JOB No. 161921

RIVERBEND CROSSING  
FILING NO. 1 & 2  
FOUNTAIN, COLORADO  
AVATAR FOUNTAIN, LP

ENGINEERING  
GEOLOGY MAP

SHEET No.  
**FIG-7**

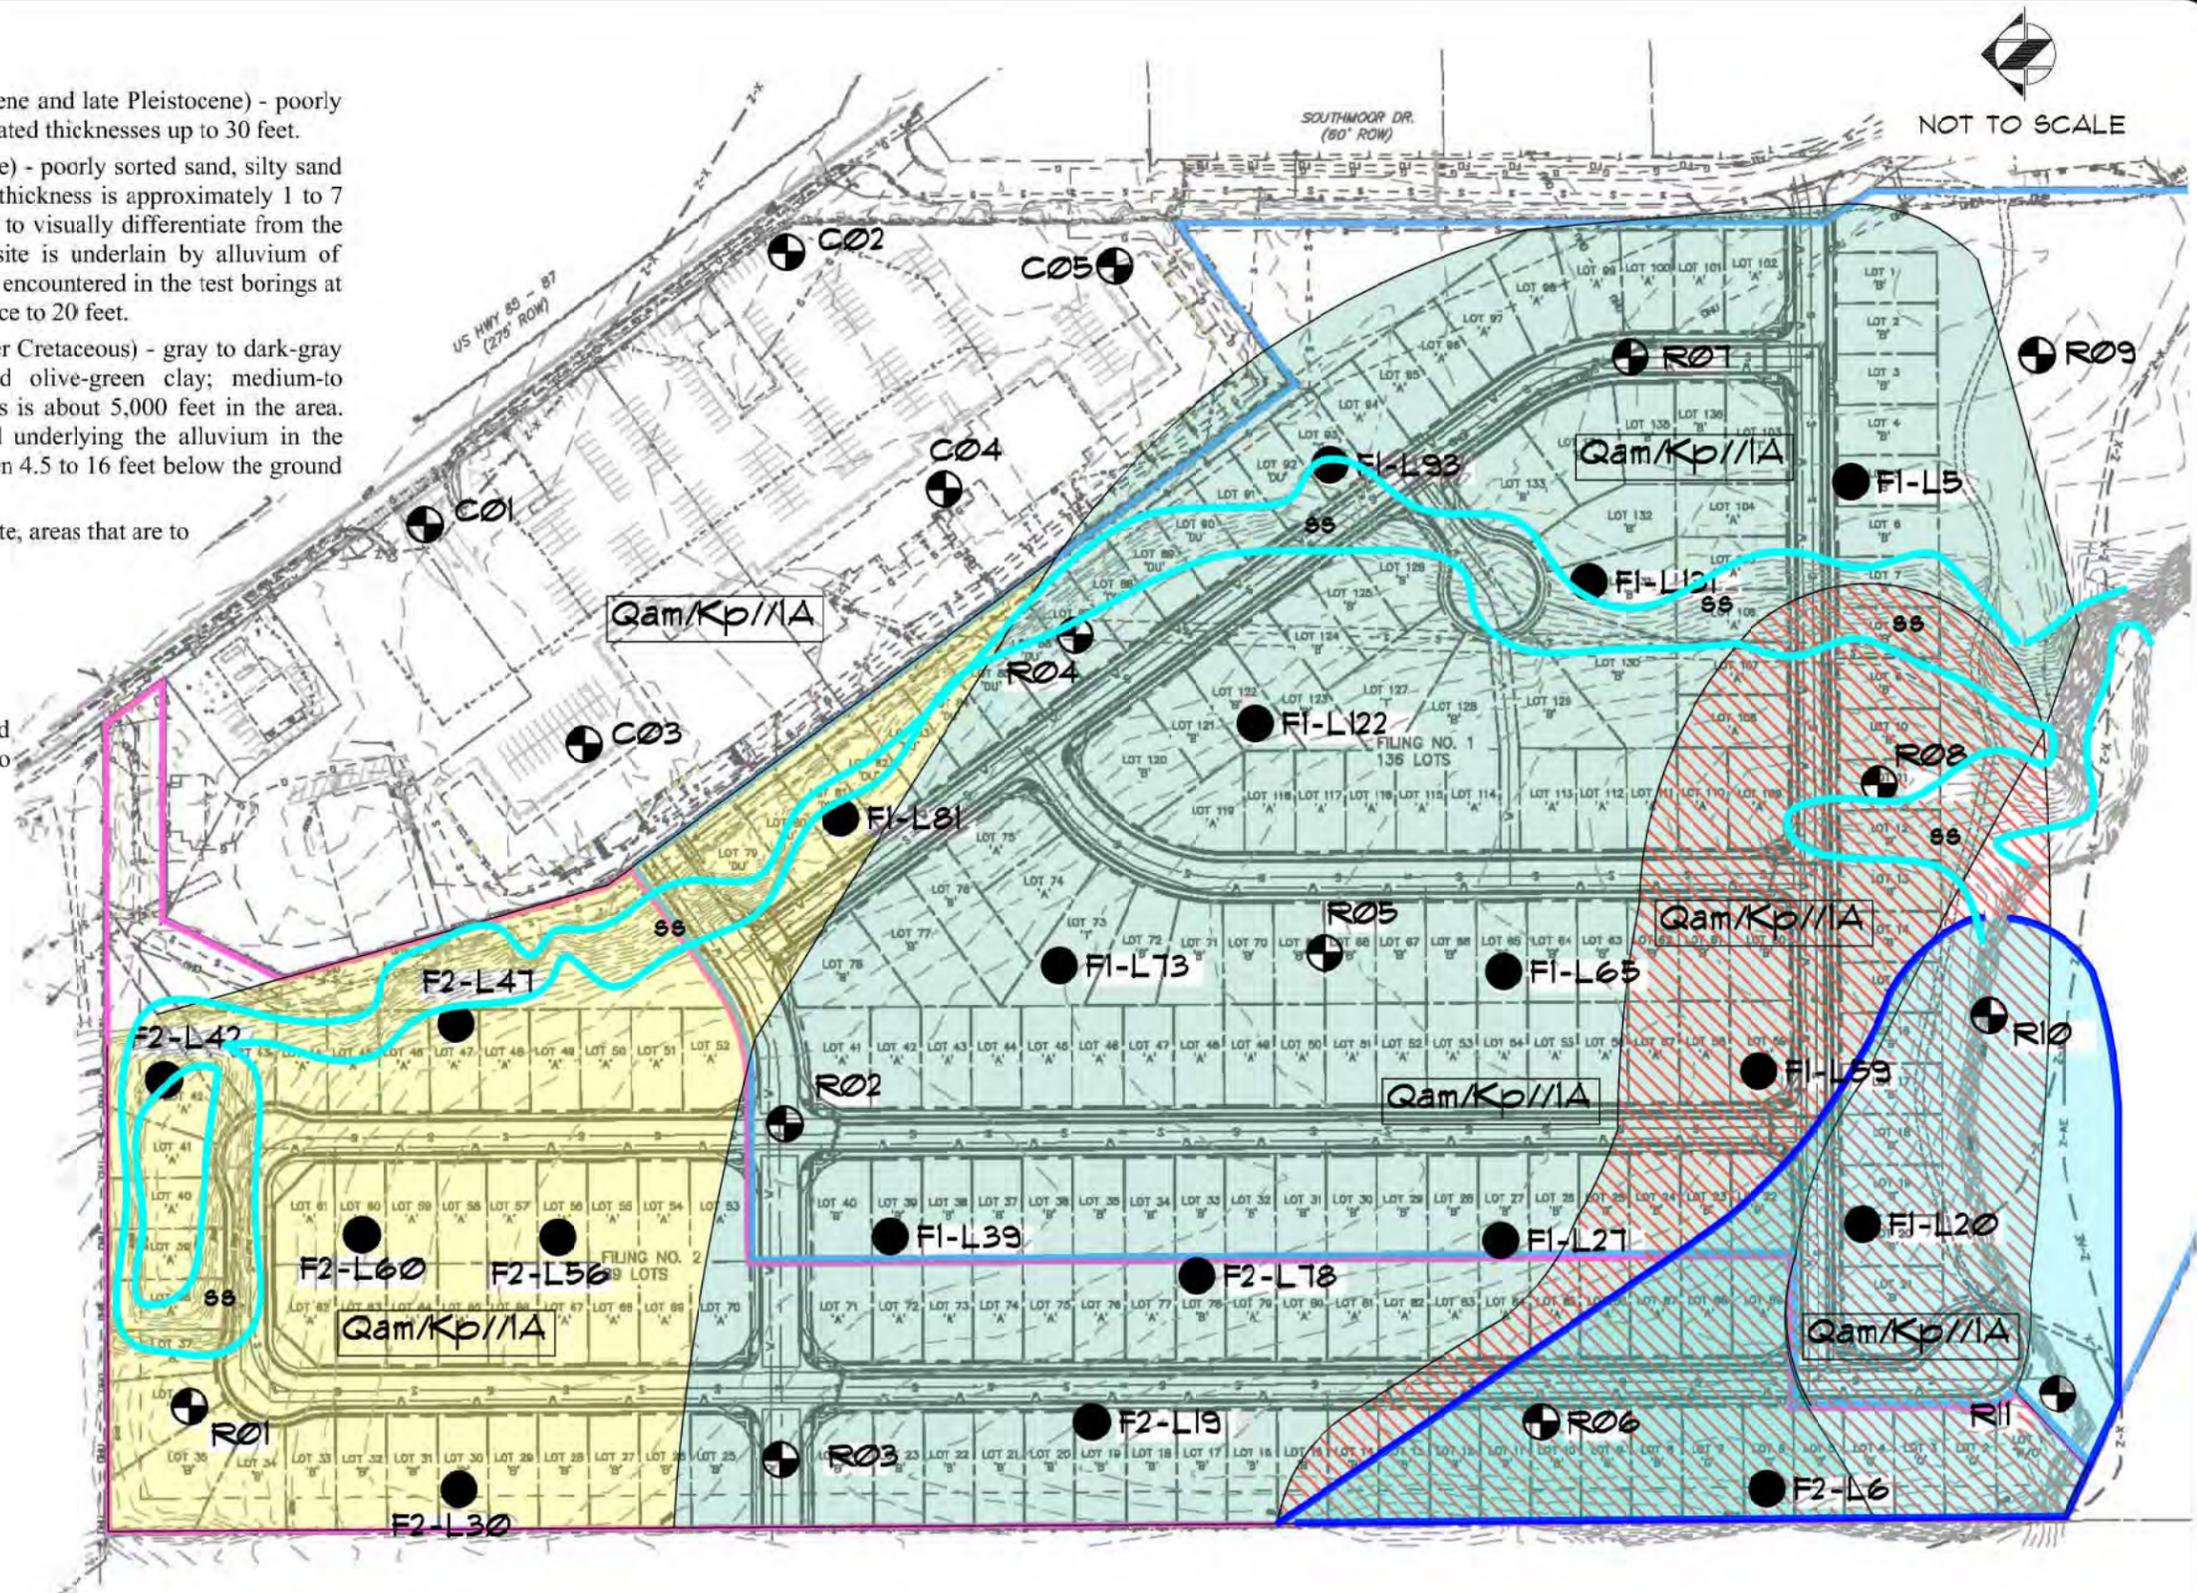
Update the Figure. The subdivision and lot layout has changed. The impacted lot numbers are different.
